Global technical regulation No. 9 (Pedestrian safety) – Phase 2 of the global technical regulation

Proposal for Amendment 2

Submitted by the expert from Japan*

"Figure 13
Lower legform II; Dimensions and C.G. locations of femur, knee joint and tibia (Side view)

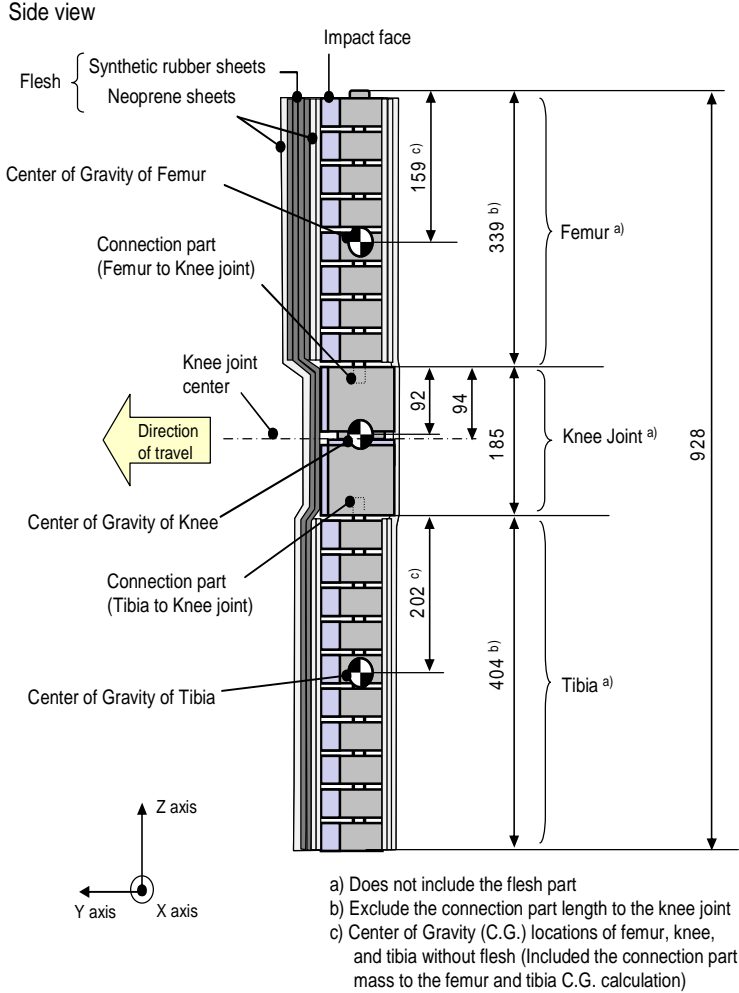
The Lower legform II shall consist of flesh, flexible long bone segments (representing femur and tibia), and a knee joint as shown in Figure 13.

The overall length of the impactor shall be 928 ± 3 mm, having a required mass of 13.2 ± 0.7 kg including flesh. The length of the femur, knee joint, and tibia shall be 339 ± 2 mm, 185 ± 1 mm, and 404 ± 2 mm respectively. The knee joint centre position shall be 94 ± 1 mm from the top of the knee joint.

The centre of gravity of the femur and tibia without flesh, including the connection part to the knee joint, shall be 159 ± 8 mm and 202 ± 10 mm respectively from the top, but not including the connection part to the knee joint, of each part as shown in Figure 13. The centre of gravity of the knee shall be 92 ± 5 mm from the top of the knee joint as shown in Figure 13.

Figure 14
Lower legform II; femur, tibia, and knee dimensions (Top view)

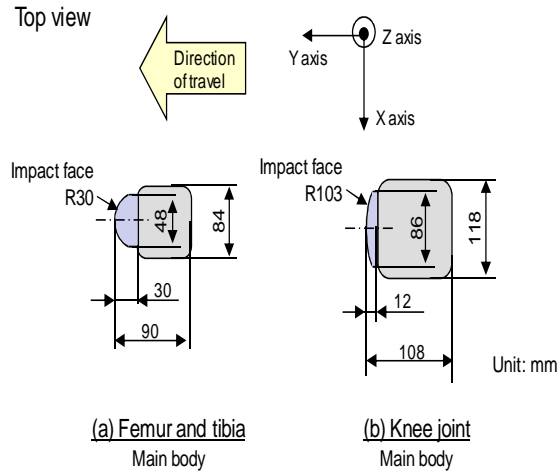
6.3.1.2.1. The cross-sectional shape perpendicular to the Z-axis of the femur and tibia main bodies shall be 90 ± 2 mm in width along the Y-axis, and 84 ± 1 mm in width along the X-axis as shown in Figure 14 (a). The impact face shall be 30 ± 1 mm in radius, 30 ± 1 mm in width along the Y-axis, and 48 ± 1 mm in width along the X-axis as shown in Figure 14 (a).

6.3.1.2.2. The cross-sectional shape perpendicular to the Z-axis of the knee joint shall be 108 ± 2 mm in width along the Y-axis, and 118 ± 1 mm in width along the X-axis as shown in Figure 14 (b). The impact face shall

be 103 ± 1 mm in radius, 12 ± 1 mm in width along the Y-axis, and 86 ± 1 mm in width along the X axis as shown in Figure 14 (b).

Figure 15
Lower legform II; flesh dimensions

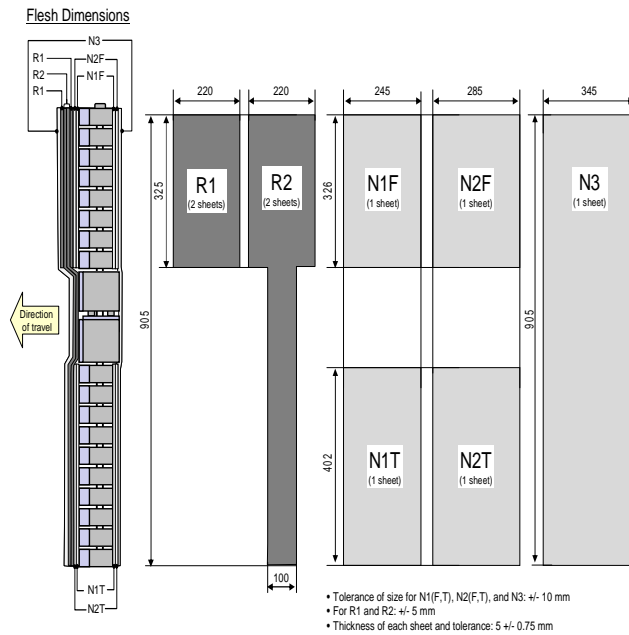
- 6.3.1.2.4. For each test, the impactor (femur, knee joint, and tibia) shall be covered by flesh composed of synthetic rubber sheets (R1, R2) and neoprene sheets (N1F, N2F, N1T, N2T, N3) as shown in Figure 15. The sheets are required to have a compression characteristic as shown in Figure 16. The compression characteristic shall be checked using the same batch of sheets as those used for the impactor flesh. The size of the sheets shall be within the requirements described in Figure 16.

Figure 16
Lower legform II; flesh compression characteristics

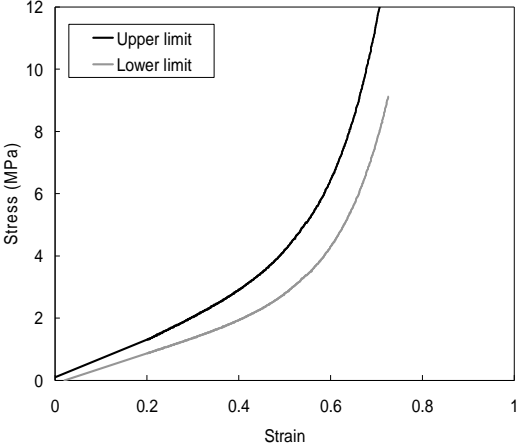
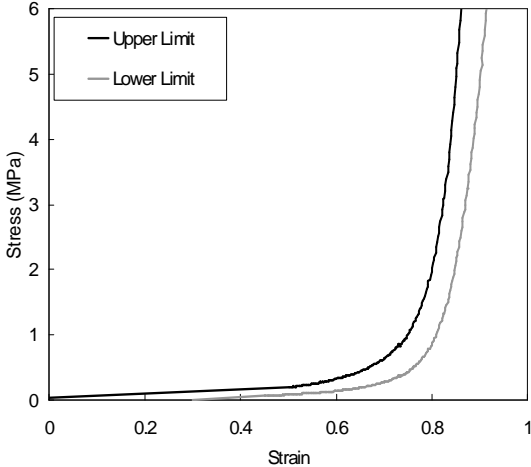
8.2.1.5. The edges of the knee joint, not bending parts, shall be mounted to the support rig firmly as shown in Figure 35. The Y-axis of the impactor shall be parallel to the loading axis within $180 \pm 2^{\circ}$. In order to avoid friction errors, roller plates shall be set underneath the support rigs. To avoid impactor damage, a neoprene sheet shall be set underneath the loading ram and the impactor face of the knee joint which is described in the Figure 14 shall be removed. The neoprene sheet used in this test shall have compression characteristics as shown in Figure 16.

Figure 17
Lower legform II; instrument locations
Instruments locations

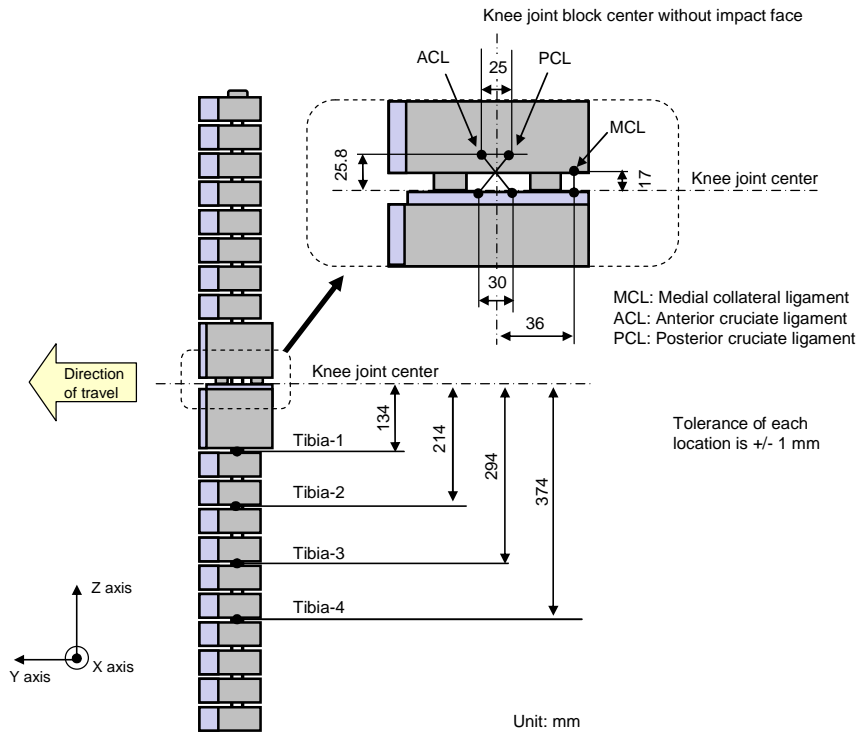
- 6.3.1.2.6.1. Four transducers shall be installed in the tibia to measure bending moments applied to the tibia. The sensing locations of each of the transducers are as follows: tibia-1: 134 ± 1 mm, tibia-2: 214 ± 1 mm, tibia-3: 294 ± 1 mm and tibia-4: 374 ± 1 mm below the knee joint centre respectively as shown in Figure 17. The measurement axis of each transducer shall be the X-axis of the impactor.

- 6.3.1.2.6.2. Three transducers shall be installed in the knee joint to measure elongations of the medial collateral ligament (MCL), anterior cruciate ligament (ACL), and posterior cruciate ligament (PCL). The measurement locations of each transducer are shown in Figure 17. The measurement locations shall be within ± 4 mm along the X-axis from the knee joint centre.

Tolerances of angles for the Lower legform II at the time of the first impact (see paragraphs 7.1.2.2. and 7.1.2.3.2.)

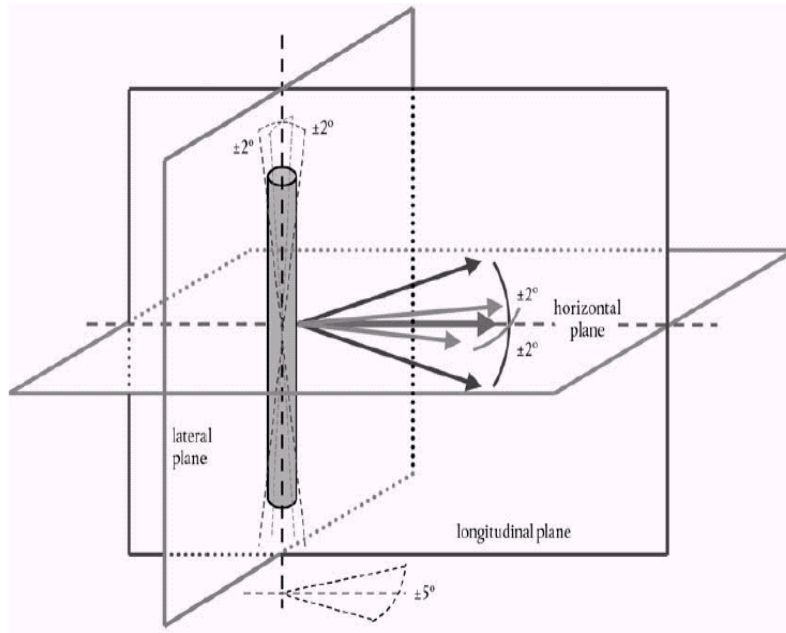
7.1.2.2. The direction of the impact velocity vector shall be in the horizontal plane and parallel to the longitudinal vertical plane of the vehicle. The tolerance for the direction of the velocity vector in the horizontal plane and in the longitudinal plane shall be $\pm 2^\circ$ at the time of first contact. The axis of the impactor shall be perpendicular to the horizontal plane, with a roll and pitch angle tolerance of $\pm 2^\circ$ in the lateral and longitudinal plane. The horizontal, longitudinal and lateral planes are orthogonal to each other (see Figure 23).

- 7.1.2.3.2. At the time of first contact the impactor shall have the intended orientation about its vertical axis, for the correct operation of its knee joint, with a yaw angle tolerance of $\pm 5^\circ$ (see Figure 23).
- 7.1.2.3.3. At the time of first contact the centre line of the impactor shall be within a ± 10 mm tolerance of the selected impact location.
- 7.1.2.3.4. During contact between the impactor and the vehicle, the impactor shall not contact the ground or any object which is not part of the vehicle.
- 7.1.2.4. The impact velocity of the impactor when striking the bumper shall be 11.1 ± 0.2 m/s. The effect of gravity shall be taken into account when the impact velocity is obtained from measurements taken before the time of first contact."

Figure 24
Lower legform II to bumper tests for complete vehicle in normal ride attitude (left) and for cut-body mounted on supports (right) (see paragraph 7.1.2.3.)

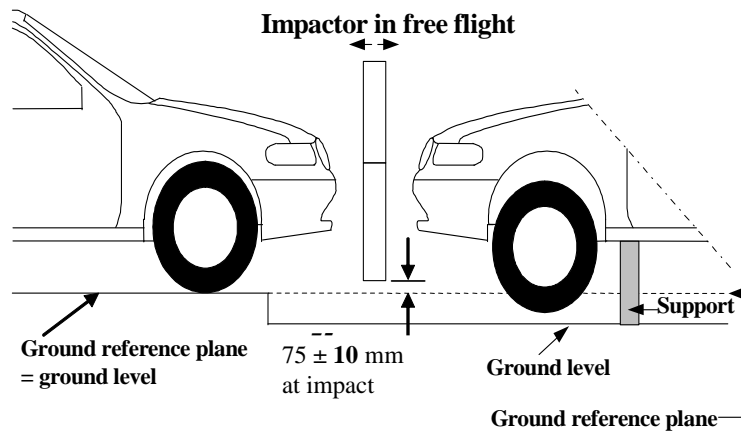
7.1.2.3. The bottom of the impactor shall be at 75 mm above ground reference plane at the time of first contact with the bumper (see Figure 24), with a ± 10 mm tolerance. When setting the height of the propulsion system, an allowance must be made for the influence of gravity during the period of free flight of the impactor.

"Figure 31
Lower legform II requirement corridor of femur and tibia in static certification test (see paragraph 8.2.1.2.)

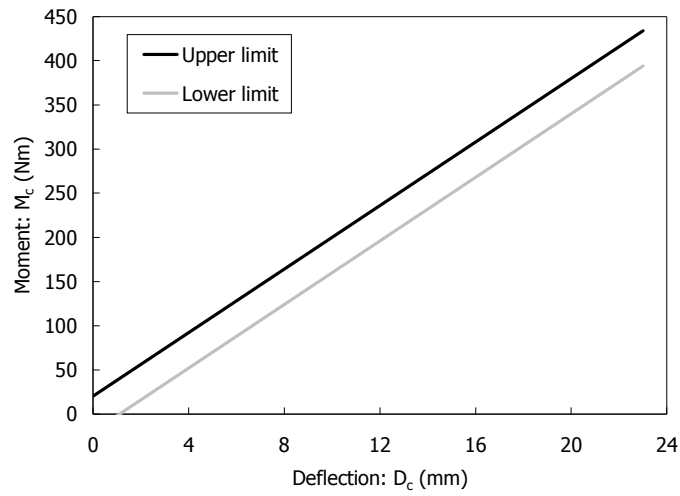
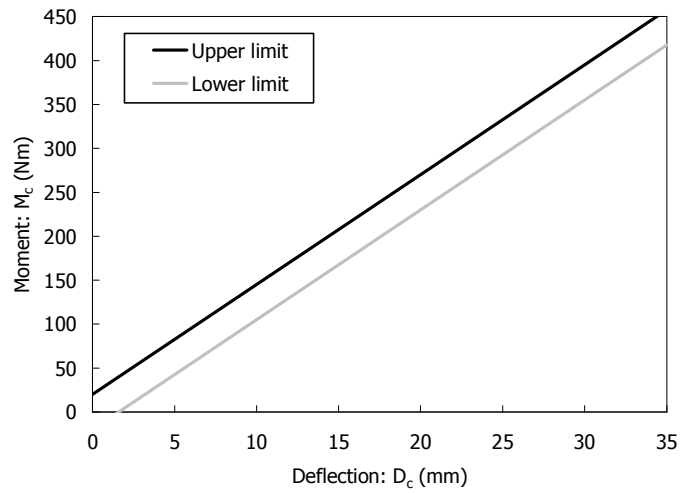
8.2.1.2. When the femur and tibia of the impactor are loaded in bending in accordance with paragraph 8.2.1.4., the applied moment and generated deflection at the centre of the femur and tibia (M_c and D_c) shall be within the corridors shown in Figure 31.

Figure 32
Lower legform II requirement corridors for knee joint in static certification test (see paragraph 8.2.1.3.)

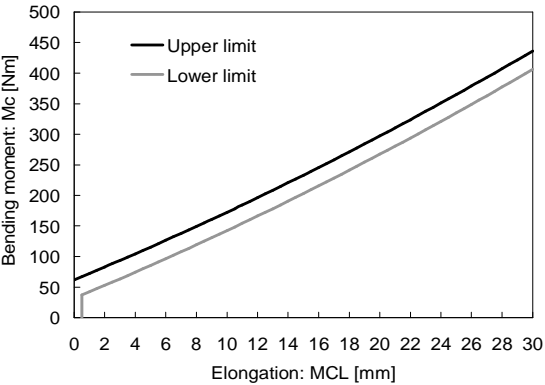
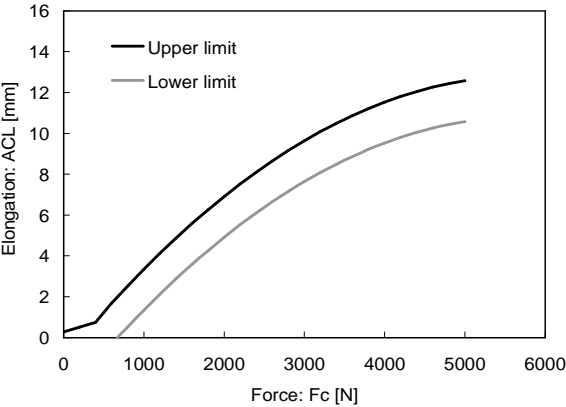
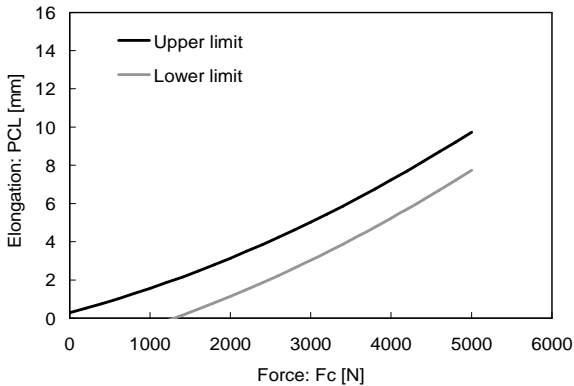
8.2.1.3. When the knee joint of the impactor is loaded in bending in accordance with paragraph 8.2.1.5., the MCL, ACL, and PCL elongations and applied bending moment or force at the centre of the knee joint (M_c or F_c) shall be within the corridors shown in Figure 32.

Lower legform II test set-up for femur in static certification tests (see paragraph 8.2.1.4.)

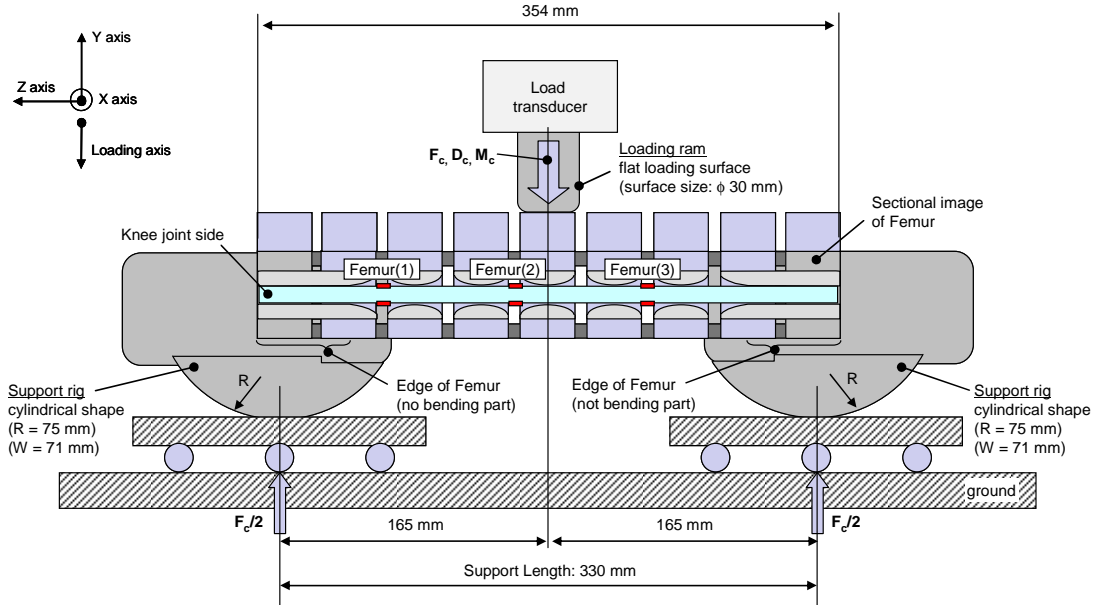
8.2.1.4. The edges of the femur and tibia, not bending parts, shall be mounted to the support rig firmly as shown in Figure 33 and Figure 34. The Y-axis of the impactor shall be parallel to the loading axis within $180 \pm 2^{\circ}$ tolerance. In order to avoid friction errors, roller plates shall be set underneath the support rigs.

The centre of the loading force shall be applied at the centre of the femur and tibia within $\pm 2^{\circ}$ tolerance along the Z-axis. The force shall be increased at a rate between 10 and 100 mm/minute until the bending moment at the centre part (M_c) of the femur or tibia reaches 400 Nm.

Figure 35
 Lower legform II test set-up for knee joint in static certification test (see paragraph 8.2.1.5.)

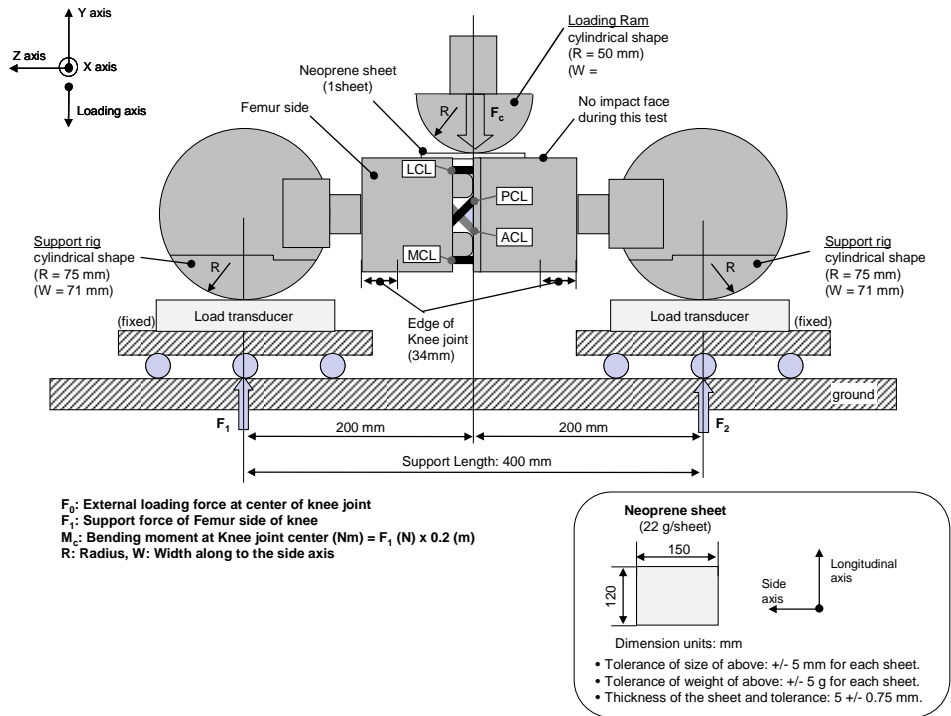
The centre of the loading force shall be applied at the centre of the knee joint within $\pm 2^{\circ}$ tolerance along the Z-axis. The external load shall be

increased at a rate between 10 and 100 mm/minute until the bending moment at the centre part of the knee joint (M_c) reaches 400 Nm.

Figure 36
 Lower legform II test set-up for dynamic lower legform impactor certification test, pendulum type (see paragraph 8.2.2.4.)

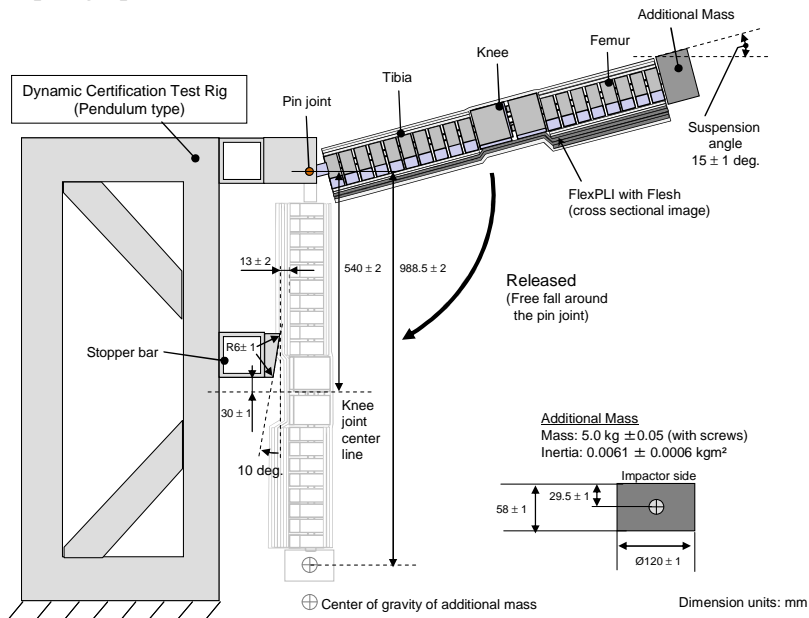
- 8.2.2.4. Test procedure**
- 8.2.2.4.1. The Lower legform II, including flesh, shall be suspended from the dynamic certification test rig $15 \pm 1^\circ$ upward from the horizontal as shown in Figure 36. The impactor shall be released from the suspended position, whereupon the impactor falls freely against the pin joint of the test rig as shown in Figure 36.**

- 8.2.2.4.2. The knee joint centre of the impactor shall be 30 ± 1 mm below the bottom line of the stopper bar, and the tibia impact face without flesh shall be located 13 ± 2 mm from the front upper edge of the stopper bar when the impactor is hanging freely as shown in Figure 36.**

Figure 37
Lower legform II test set-up for dynamic lower legform impactor certification test, inverse type (see paragraph 8.2.3.4.)

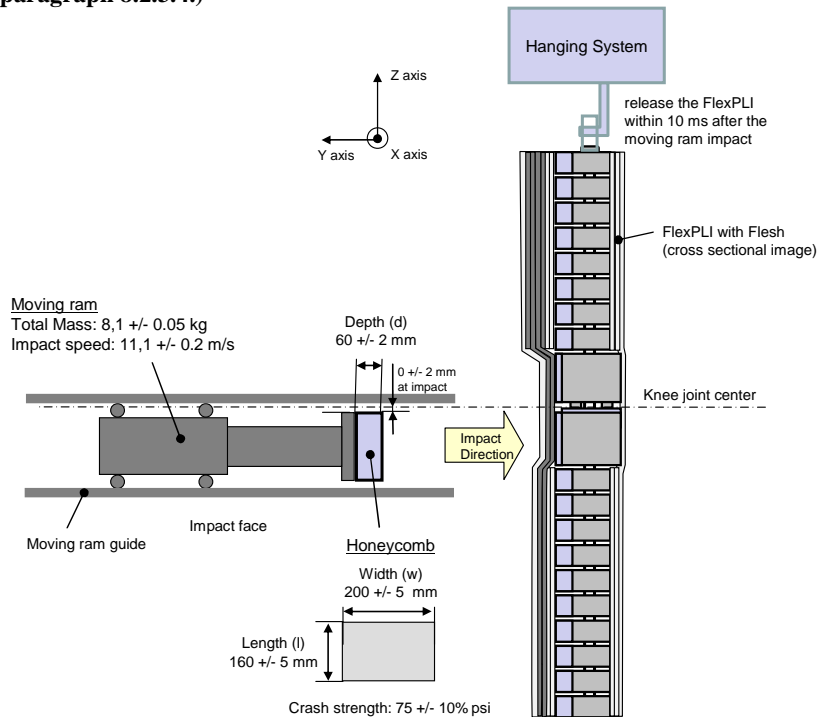
- 8.2.3.4. Test procedure
- 8.2.3.4.1. The fully assembled Lower legform II (with flesh and skin) shall be stationary suspended vertically from a test rig as shown in Figure 37. It is then impacted by the upper edge of a linearly guided Al honeycomb impactor, covered by a thin (less than 1 mm thickness) paper cloth, at an impact speed of $11,1 \pm 0,2$ m/s. The legform is to be released from the test rig within 10 ms after the time of first contact to ensure a free flight condition.

- 8.2.3.4.2. The honeycomb of 5052 alloy, which is attached in front of the moving ram, shall have a crush strength of 75 psi \pm 10 per cent and dimensions of $l = 200 \pm 5$ mm, $w = 160 \pm 5$ mm and $d = 60 \pm 2$ mm. To ensure a consistent and good level of repeatability, the honeycomb should either have a 3/16 inch cell size or a 1/4 inch cell size. The honeycomb should have a density of 2.0 pcf in combination with a 3/16 inch cell size or a density of 2.3 pcf in combination with a 1/4 inch cell size.

- 8.2.3.4.3. The upper edge of the honeycomb face is to be in line with the rigid plate of the linearly guided impactor. At the time of first contact, the upper edge of the honeycomb is to be in line with the knee joint centre line within a vertical tolerance of 0 ± 2 mm. The honeycomb shall not be deformed before the impact test.
